# Civil Engineering, Infrastructure & Siting (CEIS) Working Group Introduction

# PiP Status Update

- Figures for the CLIC PiP
  - Civil Engineering

Figure 6.1

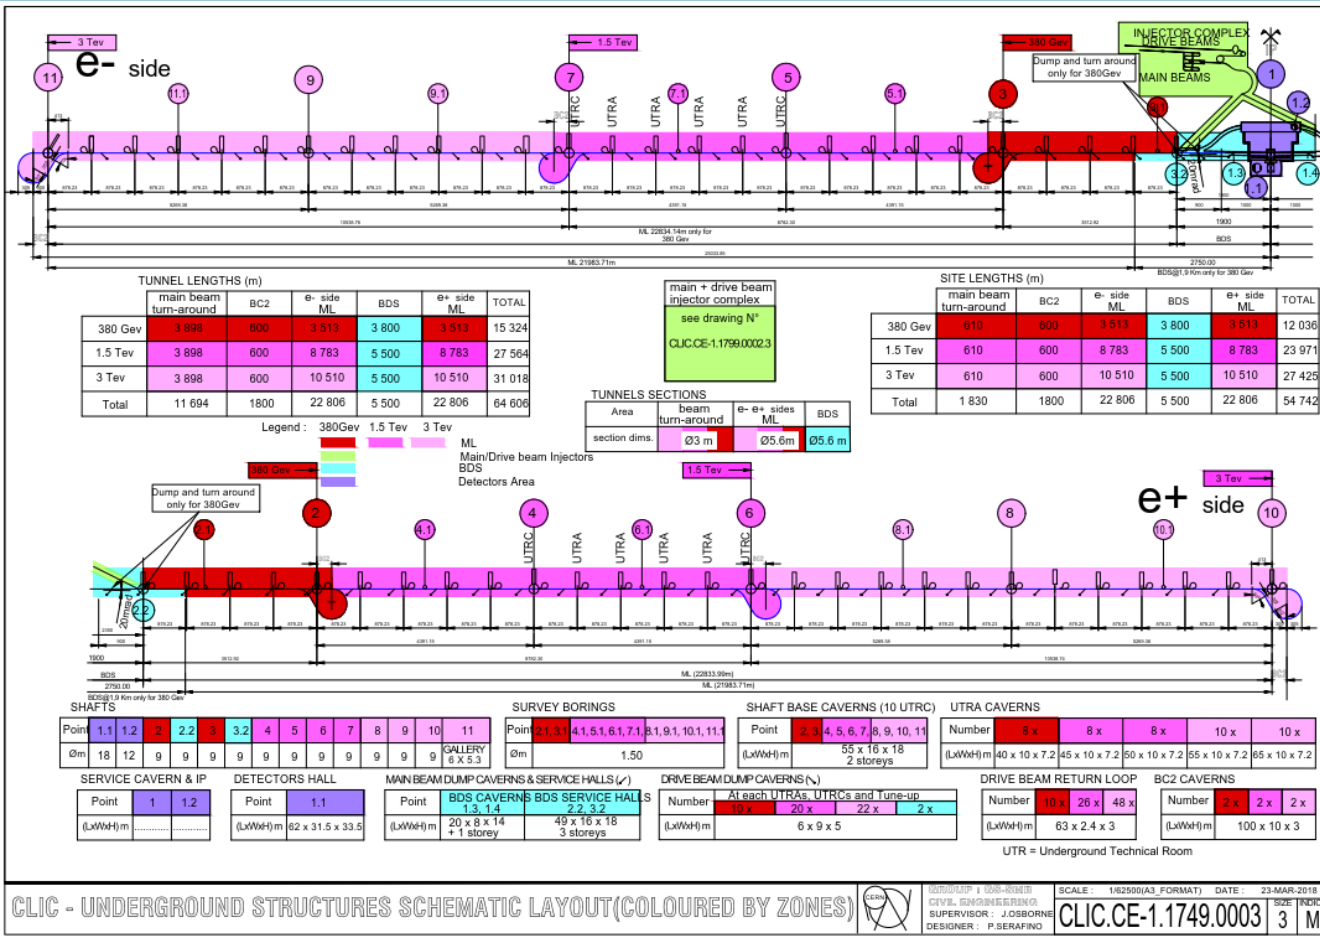
- Lengths of all tunnels correct?
- Cross-checked with beam lines as the lengths have changed multiple times.
- Difficult to read everything in the PiP, potential to reference EDMS document for a full scale Drawing

Figure 6.2

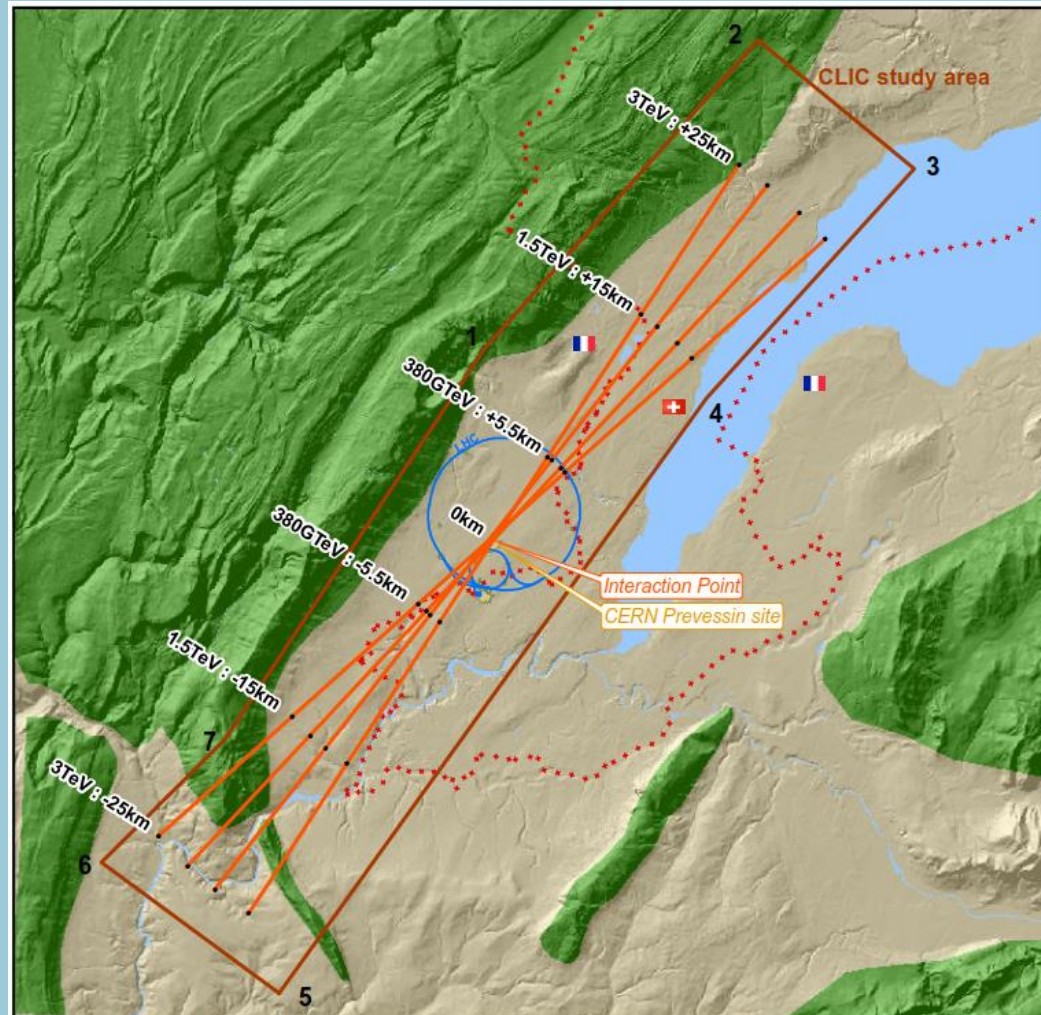
- Boundary Conditions: any comments?
- No changes needed.

Figure 6.3

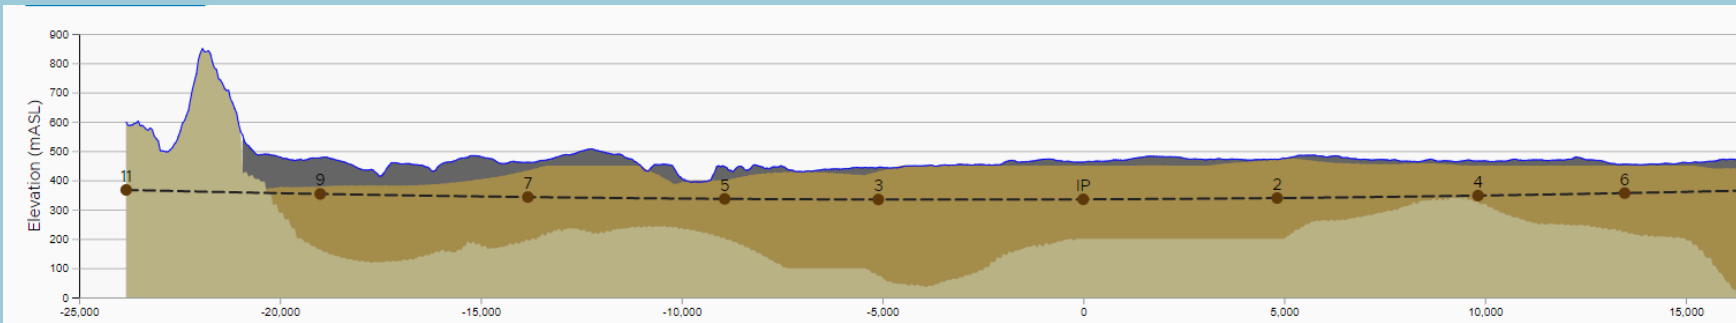
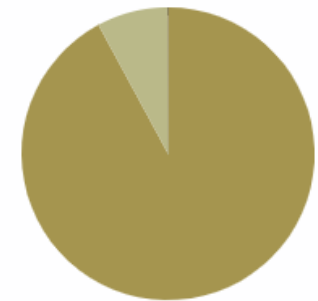
- Geological profile
- Important profile for the PiP - very difficult to see in the PiP due to length of the figure. Could potentially use a table to show the percentage of the different geology's?

Figure 6.4

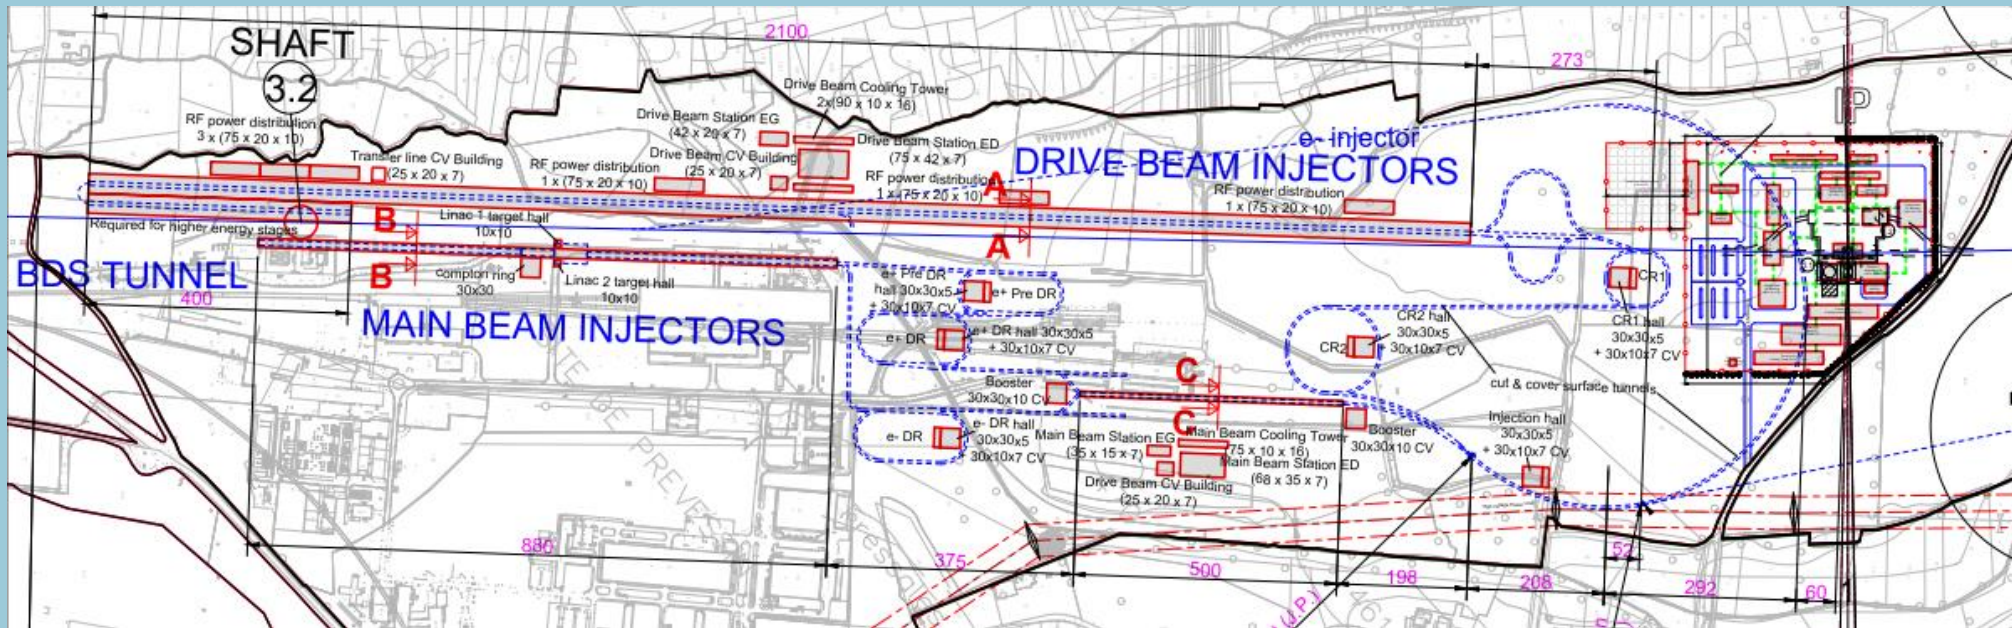
- Injection complex (DB injector length to be reduced).
- Suggested changes: decrease the visibility of the background to make the injection complex more obvious
- Check lengths of the tunnels to ensure they match up with other chapters: Andrea?

Figure 6.5

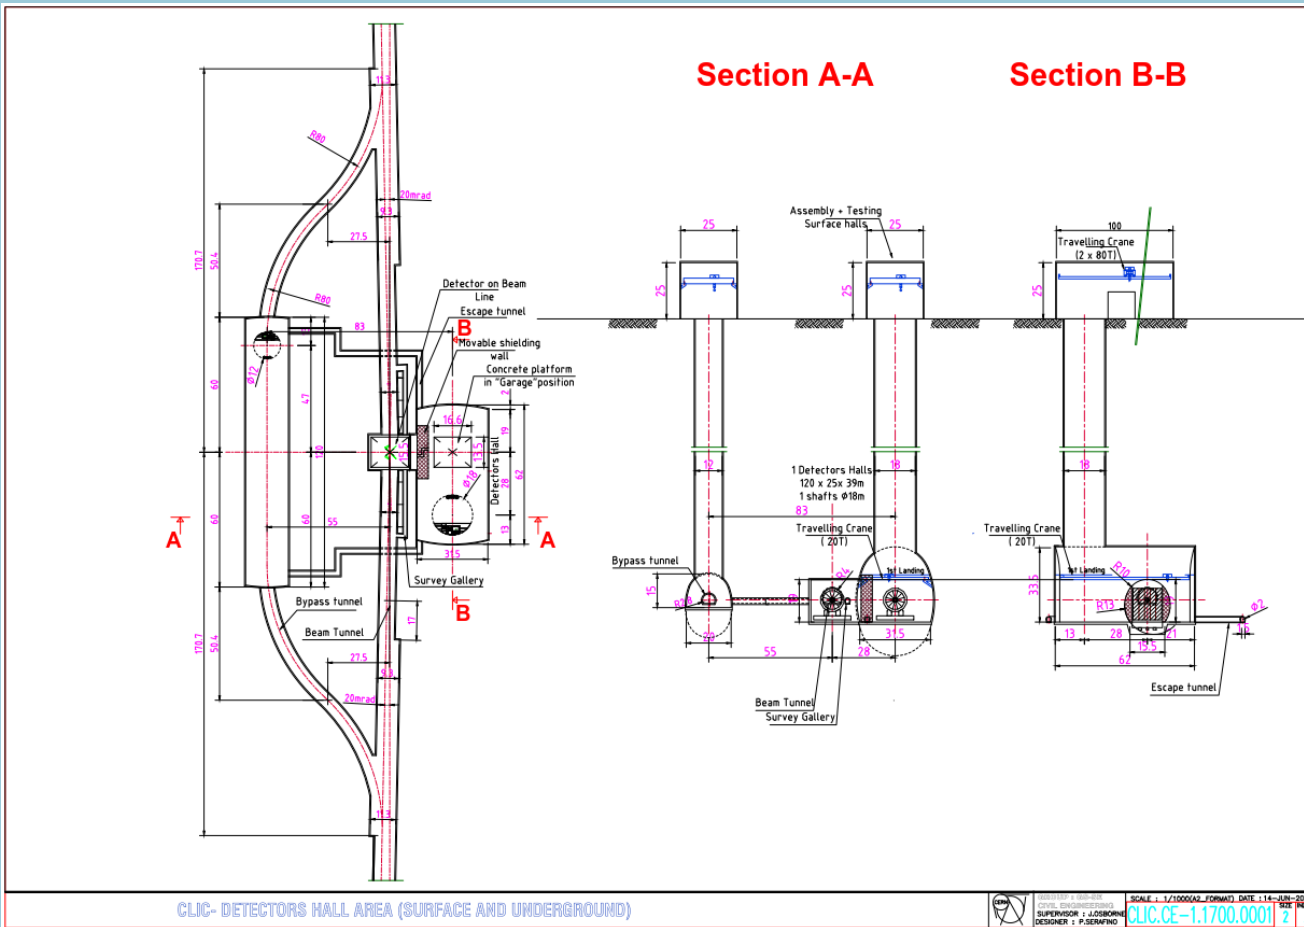
- Interaction region: No changes needed to the actual drawing.
- Make the text larger to improve the figure.
- Any other changes foreseen to the interaction region?

Figure 6.6

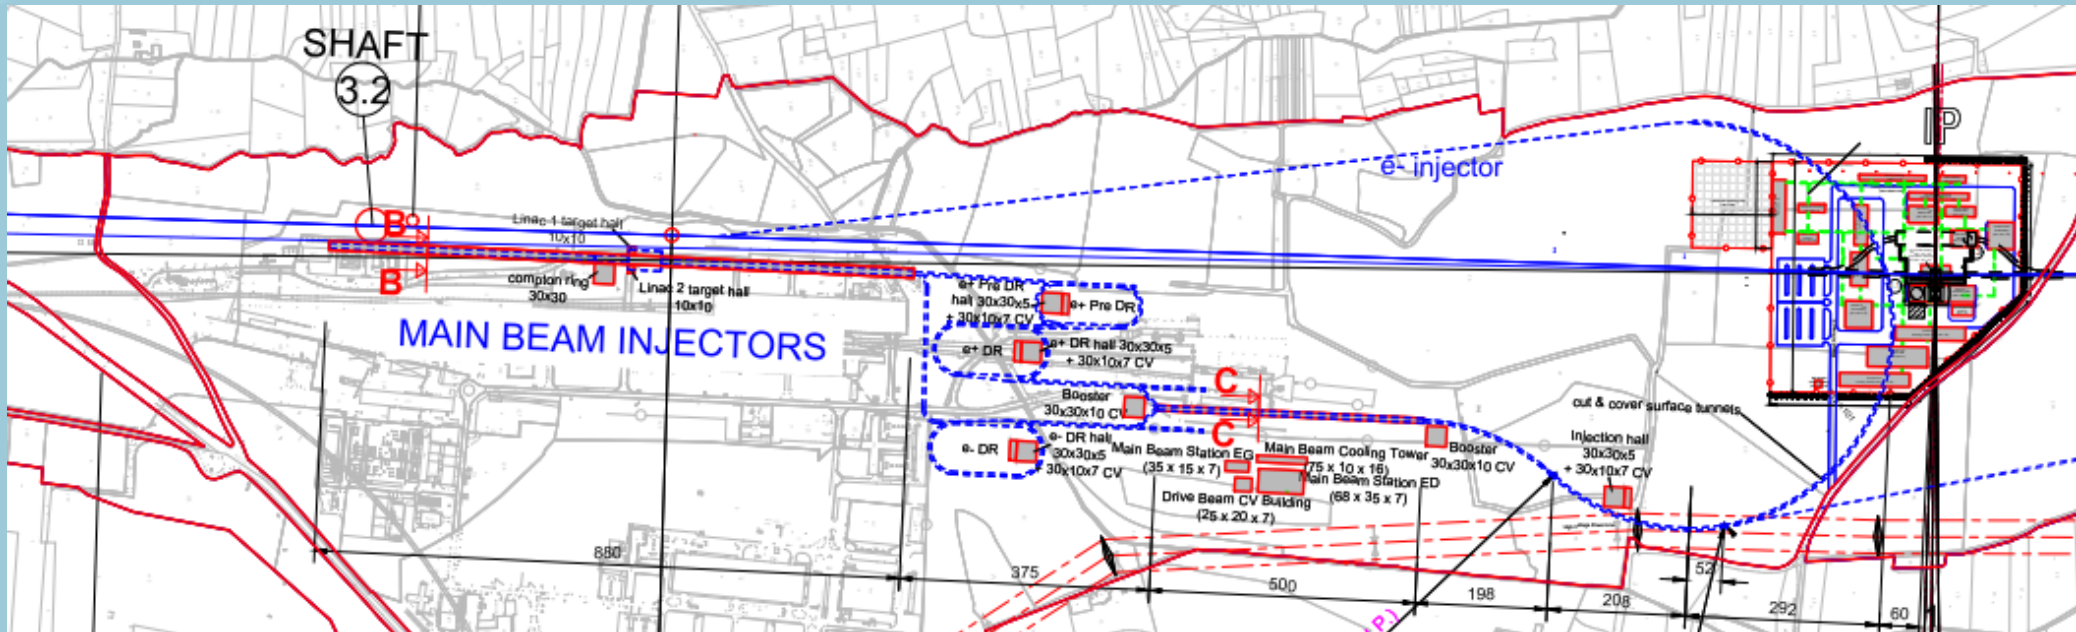
- Klystron Injection complex
- Again make the injection complex clearer by reducing the visibility of the background

Figure 6.7

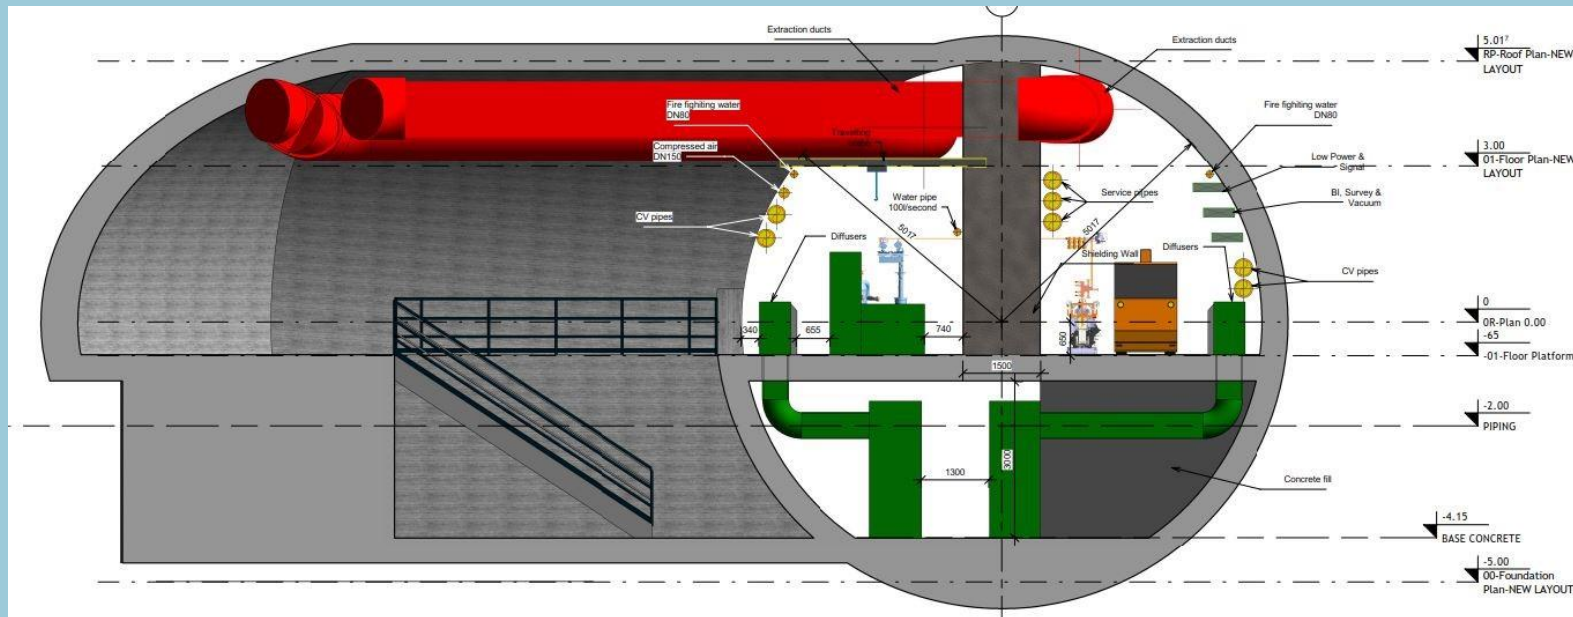
- Klystron Tunnel cross-section
- Integration of the smoke extraction required.
- Any other changes - increase text size to ensure it is legible in the document.
